**CHANGE ORDER**

No. 3

**DATE OF ISSUANCE** April 14, 2016 **EFFECTIVE DATE** April 14, 2016  
**OWNER** Lexington-Fayette Urban County Government  
**CONTRACTOR** Judy Construction Company  
**Contract:** Wolf Run Wet Weather Storage Facility  
**Project:** Wolf Run Wet Weather Storage Facility  
**OWNER'S Contract No.** WR-8; Bid No. 21-2015 **ENGINEER'S Contract No.** 200-11681-14002  
**ENGINEER** Tetra Tech, Inc.

**Change Order No. 3  
Lexington-Fayette Urban County Government  
Wolf Run Wet Weather Storage Facility**

**CHANGE ORDER**  
PROPOSED RELOCATED 42"  
SEWER PIPE AND MANHOLE

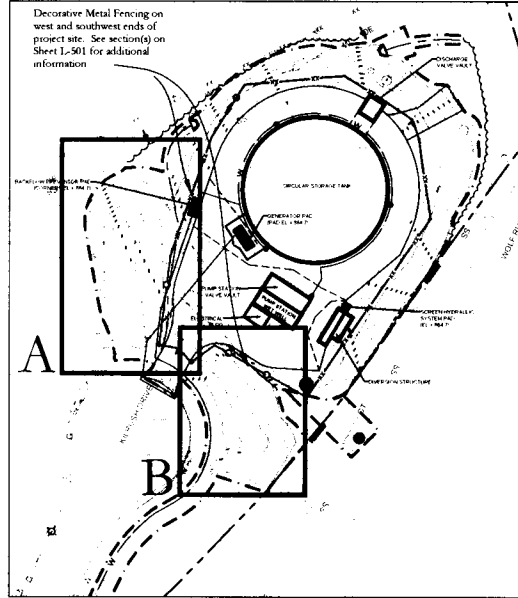
- C. Measurement and payment for this item shall be on a lump sum basis for work completed, tested and operational piping.
- D. This item includes all materials, equipment, labor, hauling, testing and incidentals required for the Contractor to complete the work shown on exhibit CO-2. Work under this item includes the installation of 170 linear feet of 42-inch FRP gravity pipe, the installation of 49 linear feet of 30-inch FRP gravity pipe, the coring of the existing manhole, and the removal of an out of service manhole. Incidental to this item is bypass pumping, and required tree removal, the removal of any required utilities.

We have prepared the following proposal for the additional 42" gravity sewer line per your drawing CO-2. Our price includes provisions to remove the existing power pole, cable and phone lines, as well as a tree by the existing manhole. The base price includes using HOBAS piping with alternate pricing for Ductile Iron and PVC.

We are concerned the existing 4' diameter manhole that we are tying the new 30" line into may need to be replaced. We have not included a new 4' diameter manhole in our price or any work associated with the existing gravity sewer line. If requested, we can provide a proposal to replace the existing manhole after it is exposed and inspected.

Judy has provided a lump sum cost of **\$148,328.00** for the additional 42-inch and 30-inch piping requested by LFUCG. Tetra Tech requested that Judy provide a price for FRP piping, PVC, and Ductile Iron. The price of \$148,328.00 is for the installation of FRP. PVC and ductile iron increase the lump sum cost \$17,819.00 and \$32,035.00 respectively. The additional piping is currently included in a future Remedial Measures Program project. LFUCG requested Judy to provide a price for the additional piping at this time to avoid disturbing the Wolf Run Wet Weather Storage Facility site with future projects. Tetra Tech recommends LFUCG approve this portion of the work, at the price given for FRP to avoid disturbing a recently finished project with future construction. The material cost for the additional piping, manholes, erosion control, pipe bedding, etc. is \$67,460.00. This material cost includes a credit to LFUCG of \$12,637.00 for the 8 foot diameter manhole and the 50 linear feet of 42-inch ductile iron pipe included in the original contract documents. The lump sum price submitted by Judy also includes \$38,694.00 in labor cost, \$19,924.00 in subcontracting cost and \$22,250.00 in overhead and profit. The subcontract costs include the cost of bypass pumping, temporary fencing, seeding and manhole coring. The overhead and profit is at the Contract Document approved fifteen percent (15%).

**CIRCULAR OPTION STORAGE TANK PLANTING PLAN**

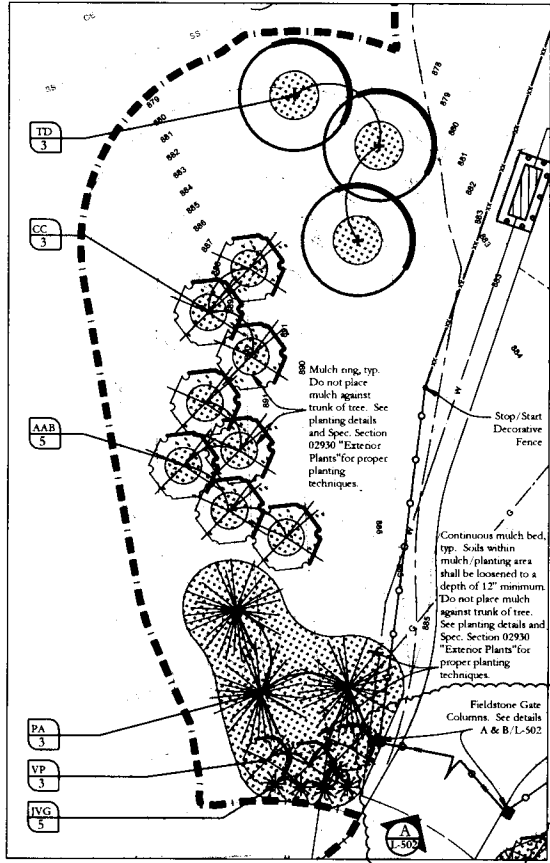
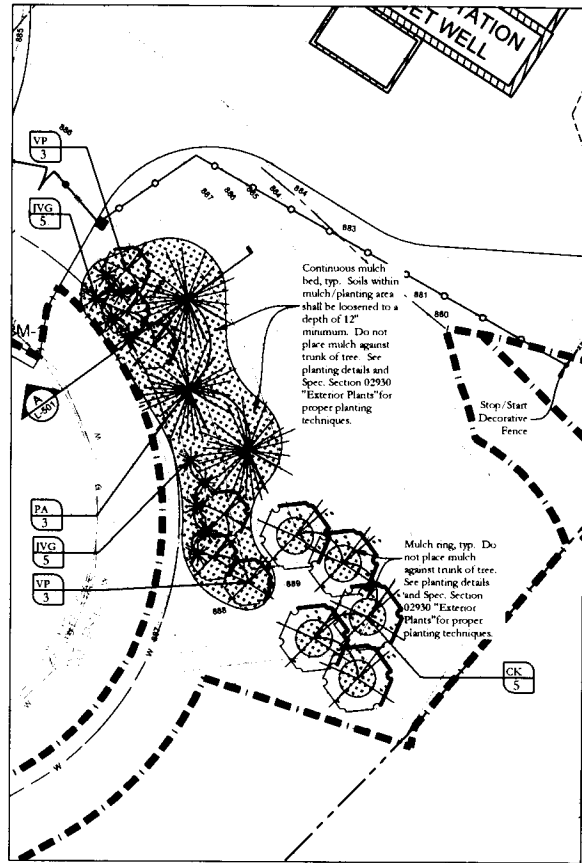
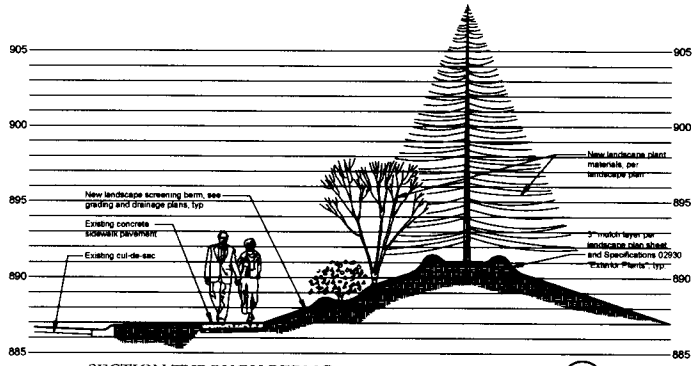
- A. Measurement and payment shall be on a lump sum basis for the architectural improvements listed below.
- B. This item includes all materials, equipment, labor, hauling, and incidentals required for the Contractor to complete the architectural improvements shown on Sheets L-201, L-501 and L-502, attached. Work under this item includes replacing a portion of the original contract chain link fence with approximately 180 linear feet of a faux wrought iron fence, installing stone columns at the entrance and changes to the landscaping plan.

We have prepared the following proposal for the architectural improvements to the landscaping and fence per your drawings L201, L501 and L502.

Decorative Metal Fencing on west and southwest ends of project site. See section(s) on Sheet L-501 for additional information

Valley neighborhood. Council Member Henson requested changes including modifications to the proposed landscaping, installation of a faux wrought iron fence in lieu of the proposed chain link fence, only for the visible portion of the proposed fence, and installing stone columns and an architectural gate in lieu of the proposed gate. Per Judy, the additional faux wrought iron fence has a lump sum cost of \$29,062.00, the modified landscaping will cost \$4,120.00 and the Masonry for the stone columns will cost approximately \$4,998. Judy provided a credit of \$8,363.00 for the material cost of the chain link fence included in the original contract documents, which is approximately \$61.50 per linear foot of fence base on 136 linear feet of fence. The material cost for the new faux wrought iron fence is \$37,425.00, approximately \$275.20 per linear foot. Tetra Tech recommends LFUCG approve this portion of the change order, as it was requested by Council Member Henson to approve the aesthetics of the tank for the surrounding neighborhood.

**L-502**

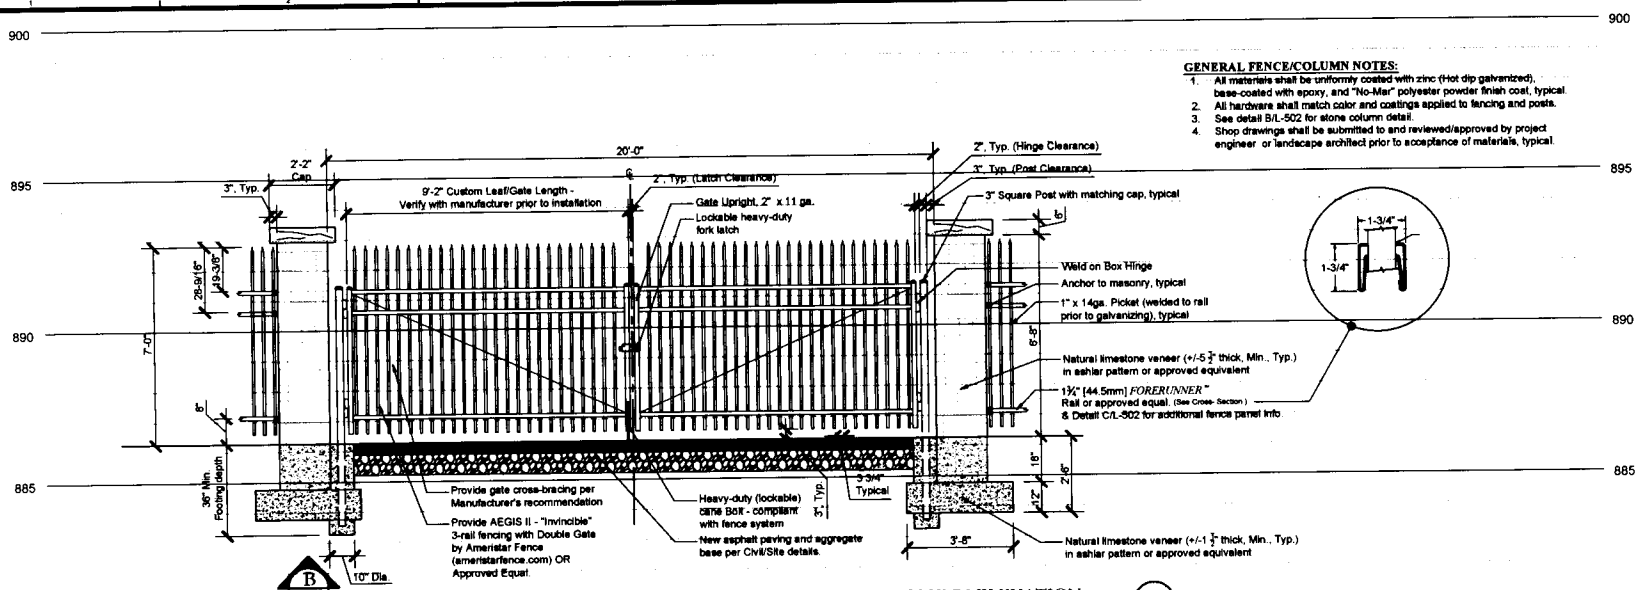
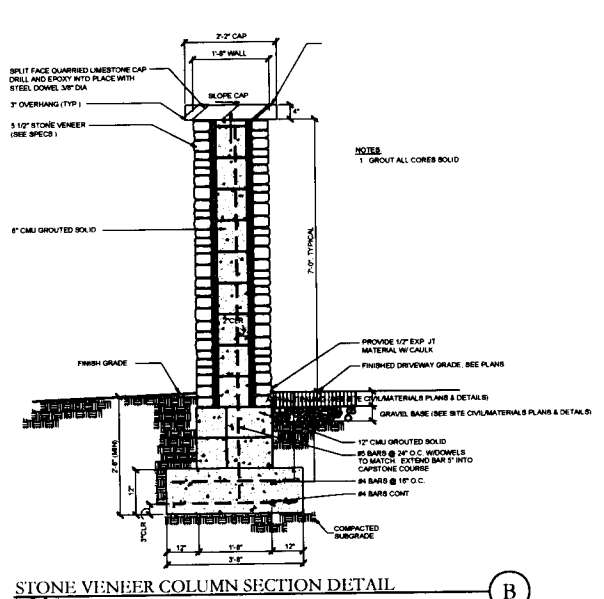
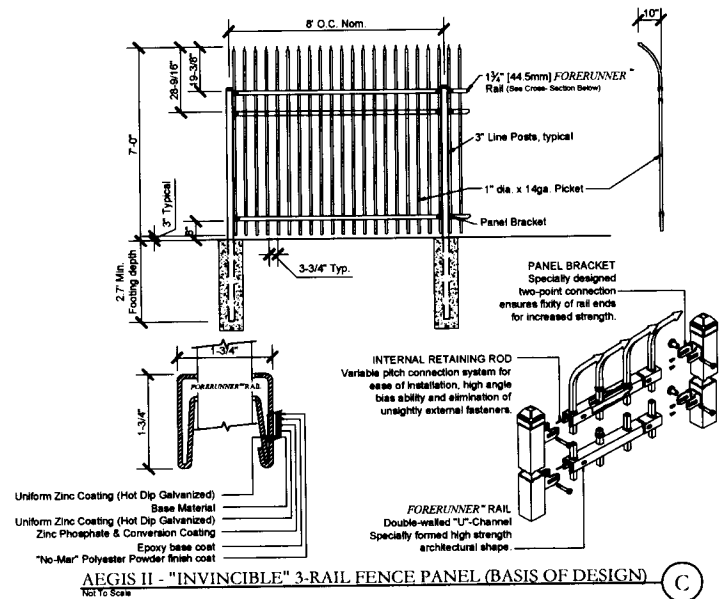
He didn't give a per foot price because the fence is panelized and has several components. He didn't want to price it by the foot because it wouldn't be accurate. There is a total of 136LF
